UNITED STATES PATENT AND TRADEMARK OFFICE

10/533,108

Office Action Summary	Application No. 10/533,108	Applicant(s) WEILAND, JOSEF	
	Examiner BRYAN R. MULLER	Art Unit 3723

DETAILED ACTION

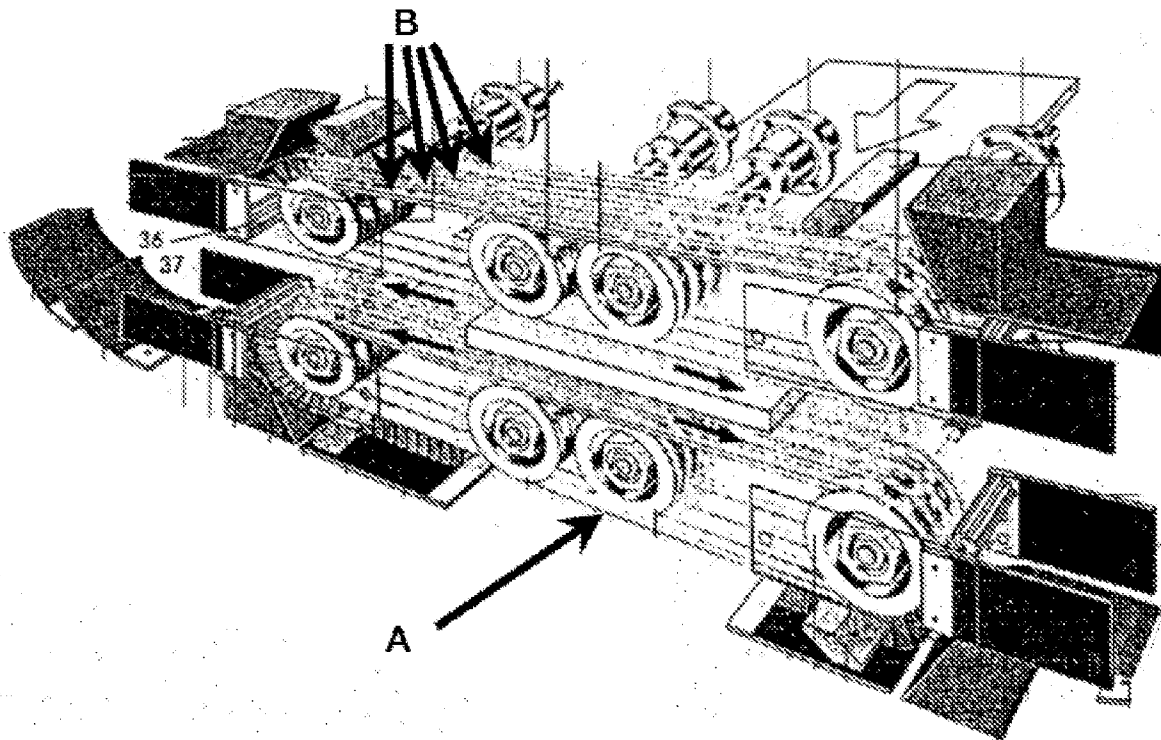
22. Finally, with regard to claim 46, the applicant further argues that there is no clear reference that conveyor devices are offset from one another on each side of the Ingromat device. However, for clarification, the Examiner has included a drawing taken from the Ingromat reference to specifically point out the brush conveyors that are offset from one another and rotate in opposite directions. The applicant also argues that the offset brushes of the Ingromat apparatus would not provide the same advantages as the applicant's claimed invention because the Ingromat reference puts no pressure on the brushes. However, as discussed *supra*, the Ingromat apparatus is capable of applying pressure between the brushes and the workpiece and regardless of the applicant's intended advantage, the Ingromat reference does provide all of the limitations regarding

the positioning of the conveyor devices relative to one another, as they are claimed in claim 46. Therefore, the applicant's intended advantage is moot in the apparatus claims.
